Final Mitigation Plan Apple Valley Project

**DMS Project #: 100063 | Contract #: 7531 | USACE Action ID: SAW- 2018-01150
DWR Project #: 20181028 | RFP: 16-007334**

Re: NCIRT Review and USACE Approval of the NCDMS Apple Valley Mitigation Site / Henderson County / SAW-2018-01150; NCDMS Project # 100063

SUBJECT: Apple Valley Mitigation Site - NCIRT Comments during 30-day Mitigation Plan Review

DRAWING TITLE:
 FENCING PLAN

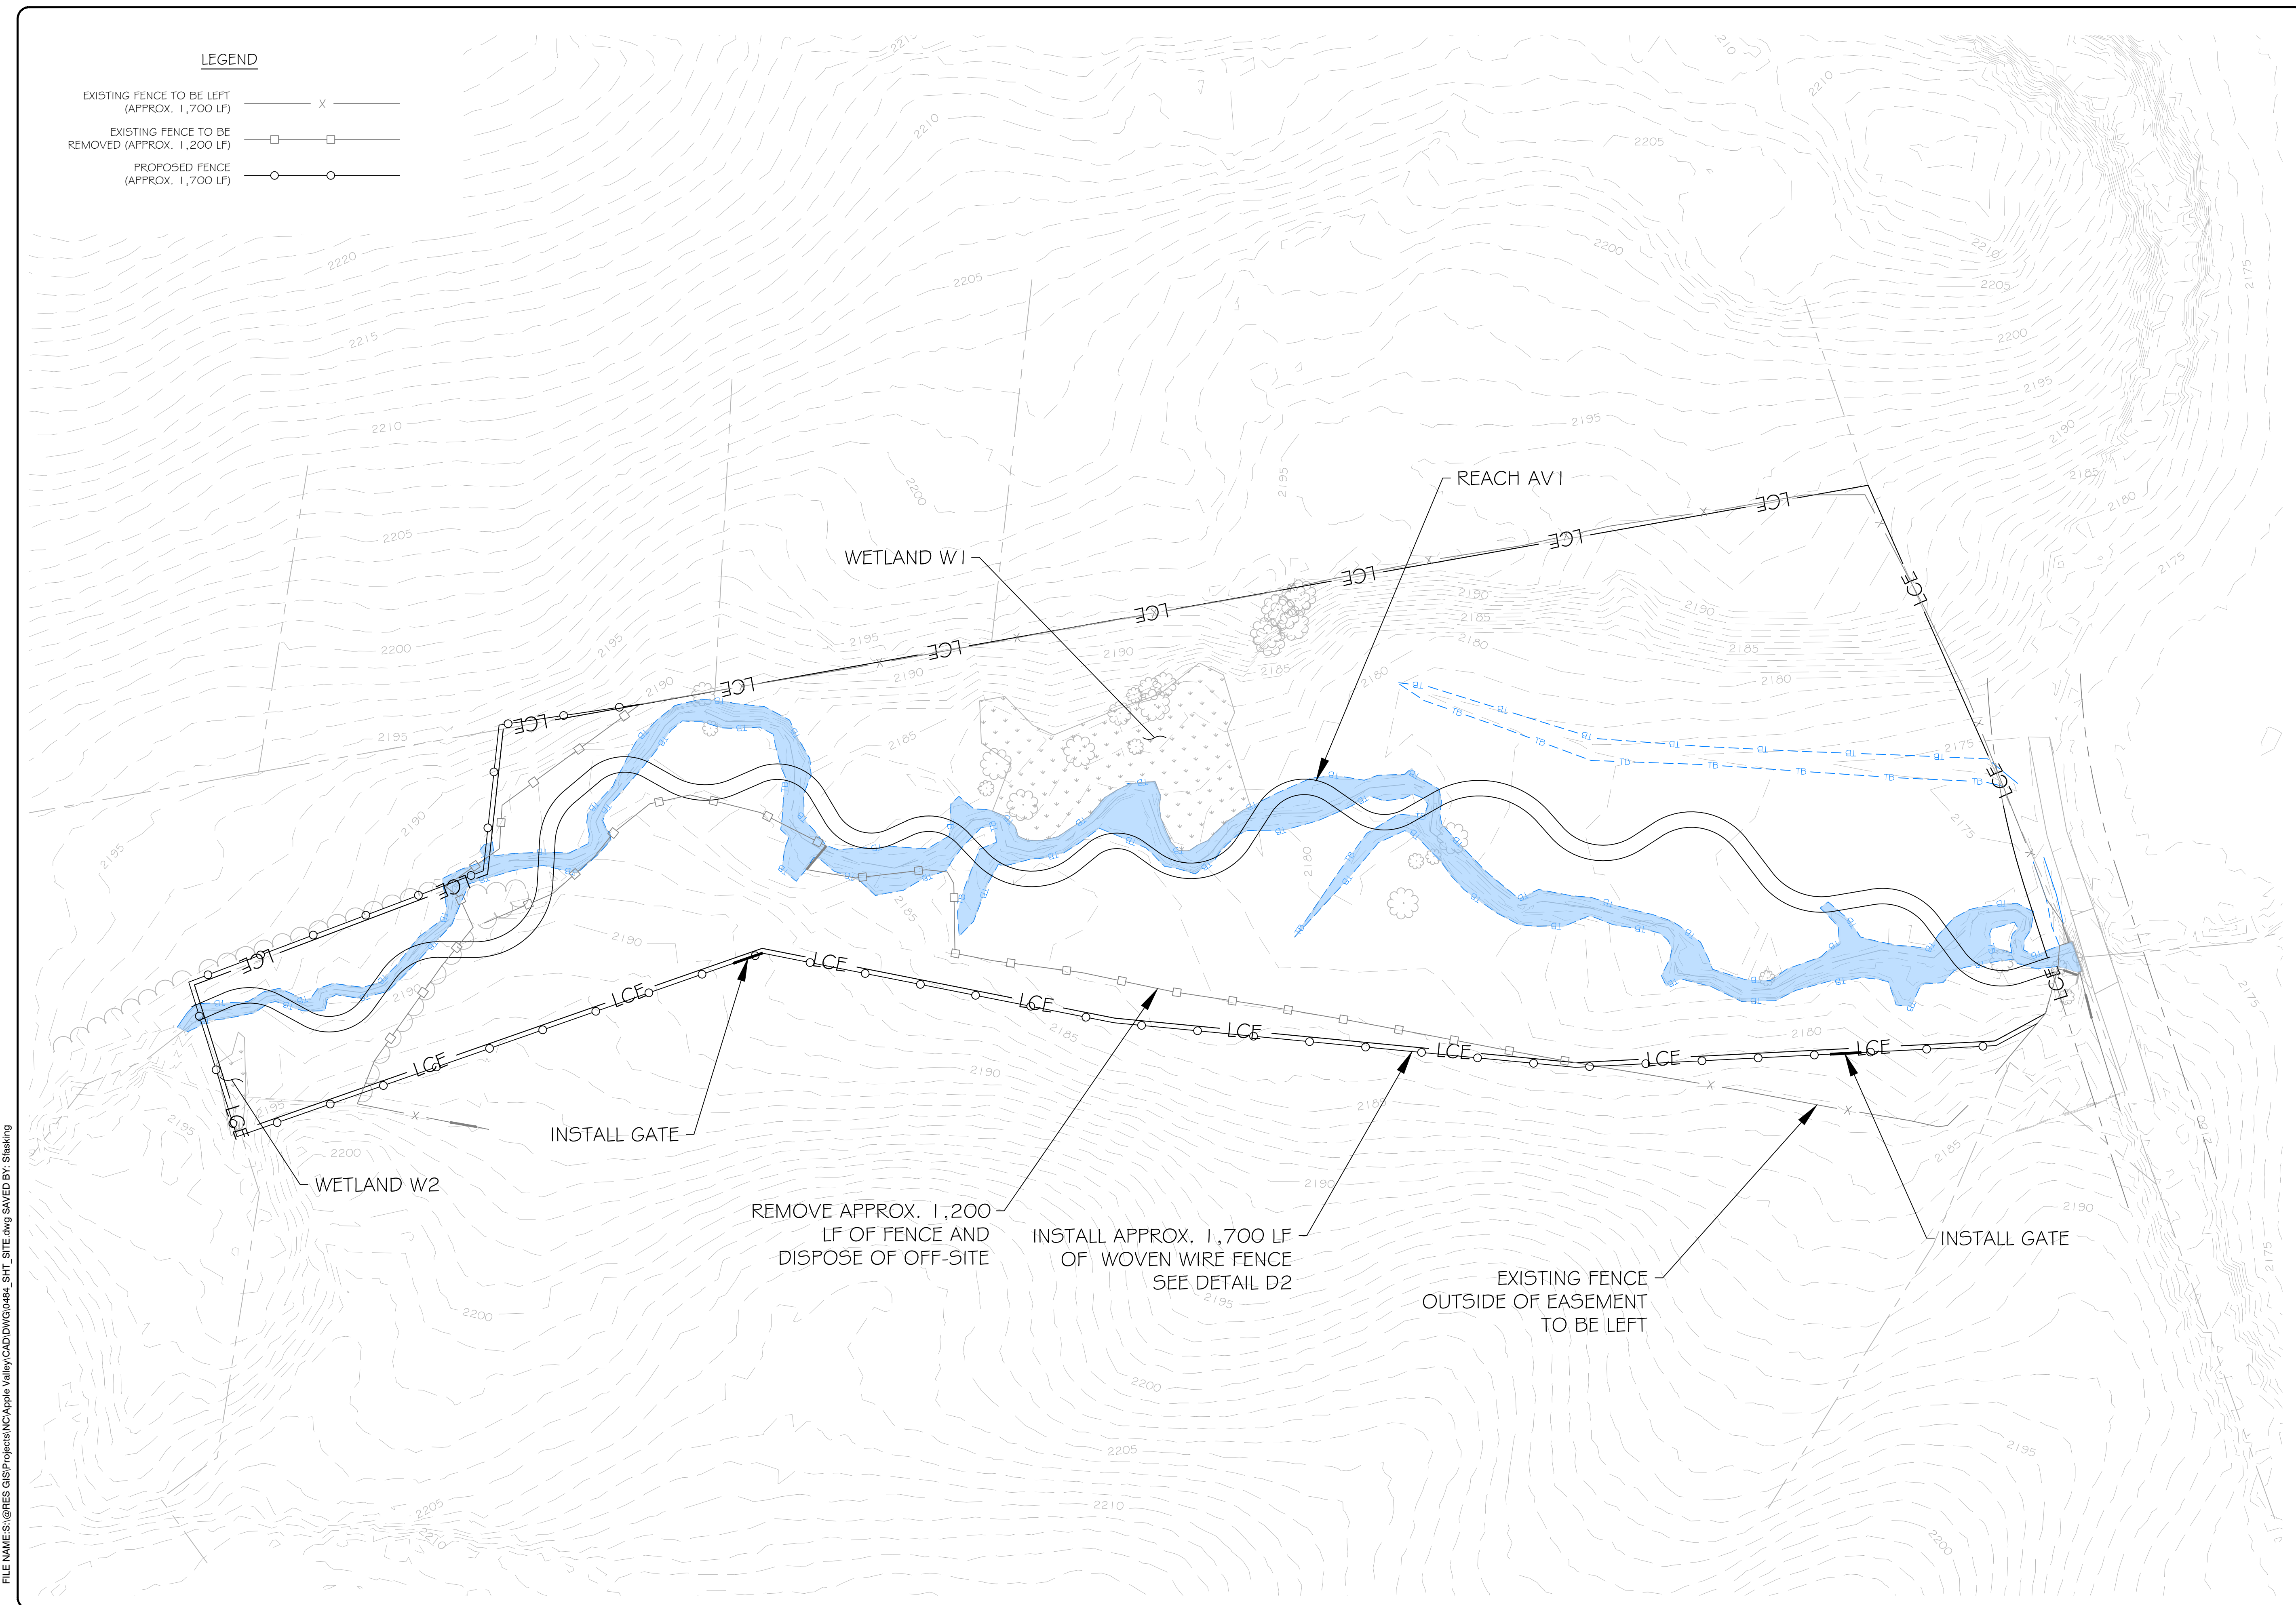
19. Sheet F1 – Please include sufficient gate points along the existing/proposed fence line for the site to be accessed by regulatory and stewardship staff.

19. Sheet F1 – Please include sufficient gate points along the existing/proposed fence line for the site to be accessed by regulatory and stewardship staff.
Gates will be installed in the fence for site access. Two gates have been added to Sheet F1 showing their proposed locations.
20. Appendix F – Please confirm that the landowner will be responsible for fence maintenance during the seven-year monitoring period.
As stated, maintenance of the livestock exclusion fencing will be the responsibility of the landowner.
21. General comment – “Reaches” plural is used multiple times throughout the plan. Please update to reflect the single project reach.
The word “Reaches” has been corrected to a singular “Reach” throughout the document.

CHANNEL BACKFILL

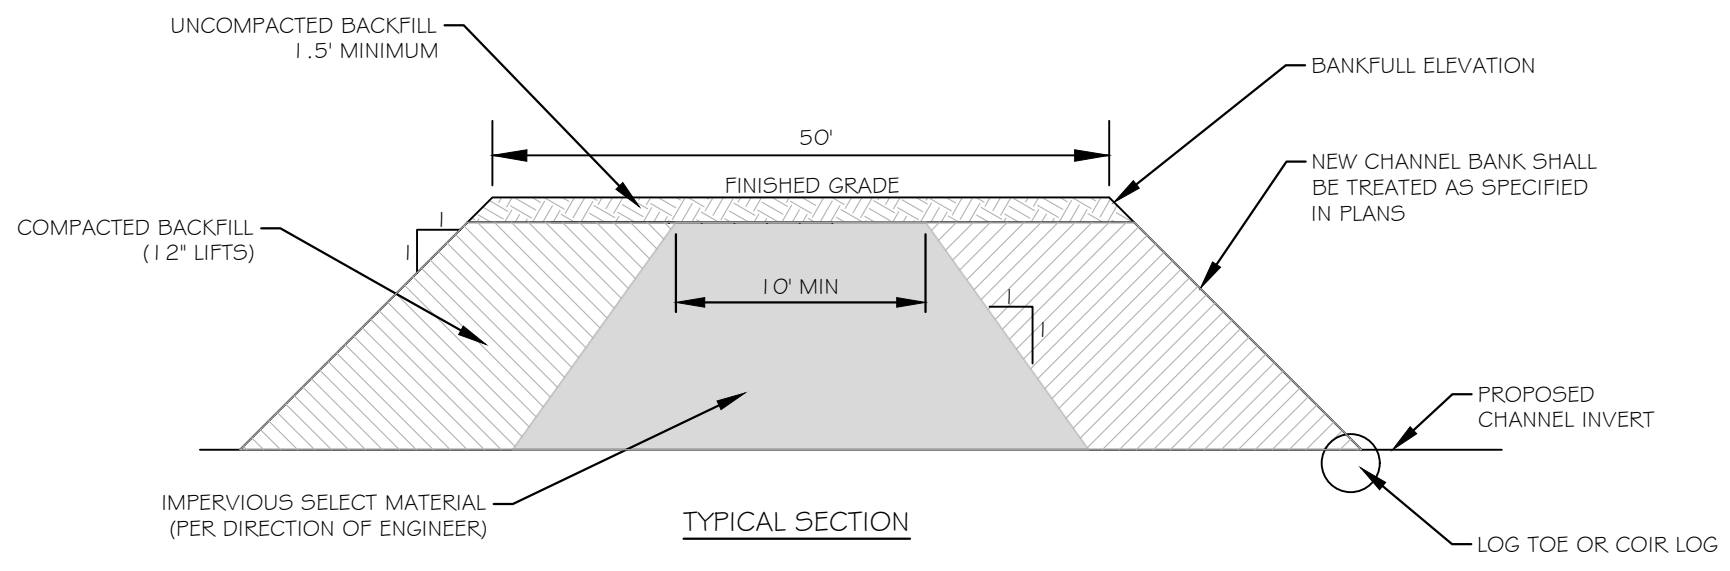
- a. In channel or ditch sections to be backfilled below top of bank, please consider planting obligate species if there is a likelihood of standing water during the growing season.

- b. Sheet D2 – DWR would like to see a minimum channel plug length of 50 feet rather than 30 feet.
18. Sheet D3 –
 - a. DWR generally prefers the use of brush toe over the single log toe protection treatment.

17. Sheet D2 –
- a. In channel or ditch sections to be backfilled below top of bank, please consider planting obligate species if there is a likelihood of standing water during the growing season.
RES will do its best to plant bare roots and seed mixes in their preferred habitat during site planting.

- b. DWR would like to see a minimum channel plug length of 50 feet rather than 30 feet.
Plug length has been updated per the comment.
18. Sheet D3 –
- a. DWR generally prefers the use of brush toe over the single log toe protection treatment.
Log toe protection will not be used on this project; references to log toes have been removed from the planset.

BRUSH TOE

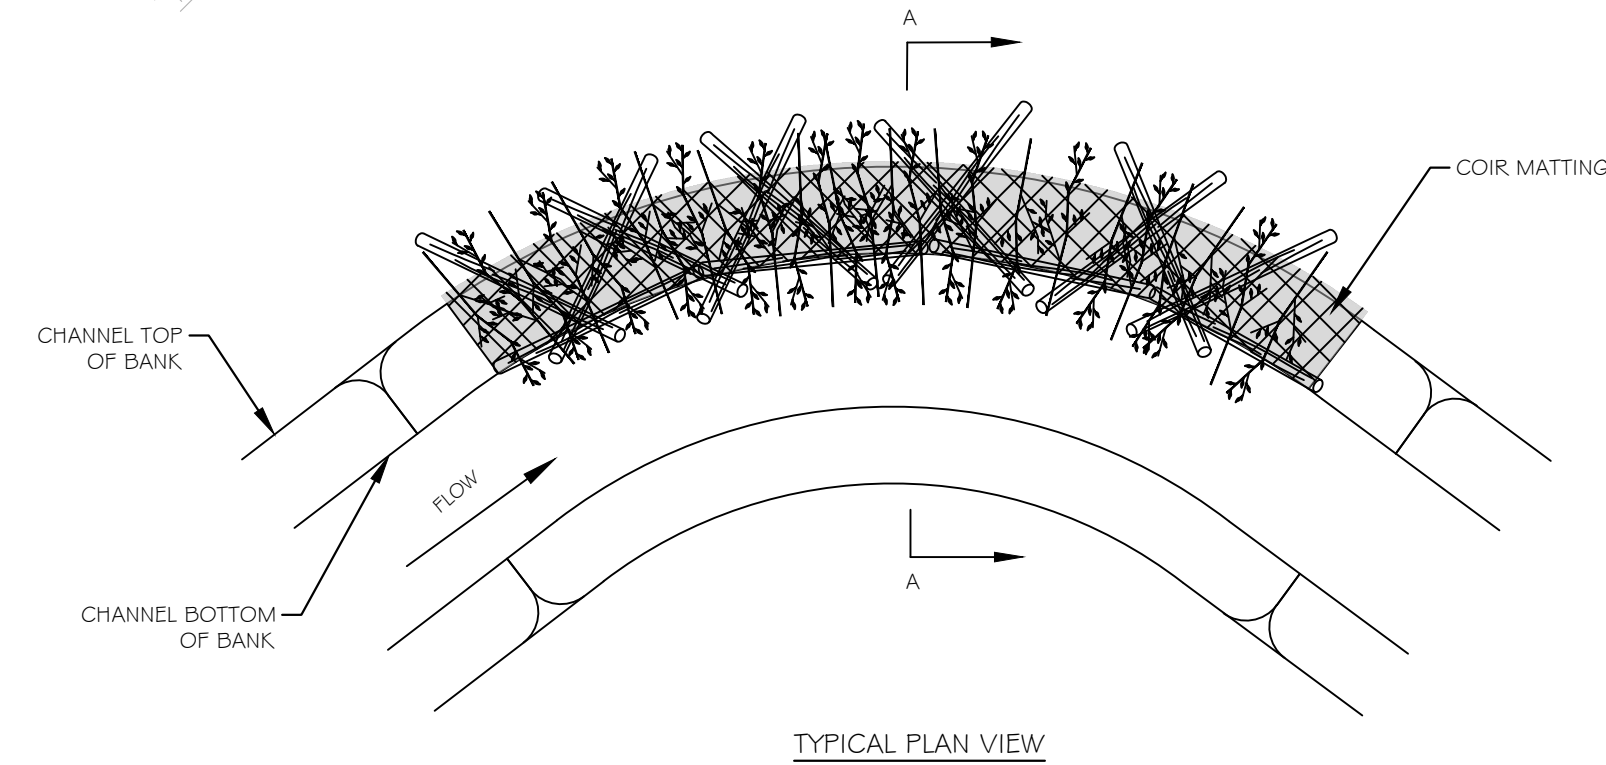
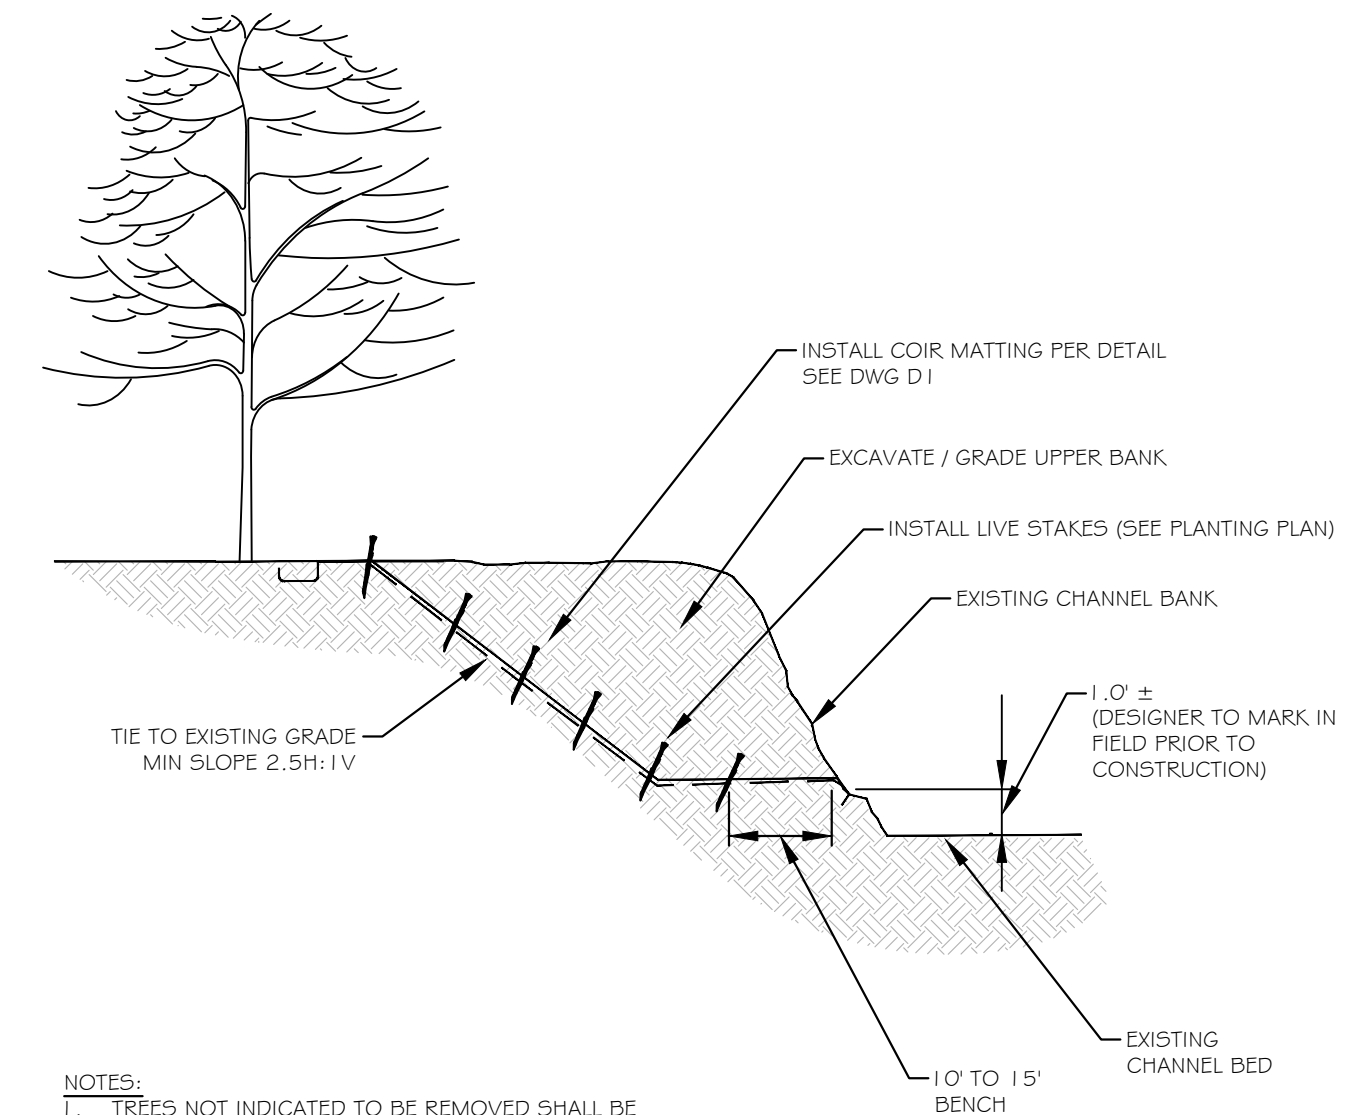
- b. Sheet D3 – The brush toe note #3 refers to silky willow, which should be updated to tag alder or also included in the plant list.
 - c. Sheet D3 – Sod mats are identified as a potential bank stabilization treatment. Please include a detail for this treatment in Appendix A or add treatment information to applicable existing detail(s).

- b. The brush toe note #3 refers to silky willow, which should be updated to tag alder or also included in the plant list.
Silky willow has been updated to tag alder per the comment.
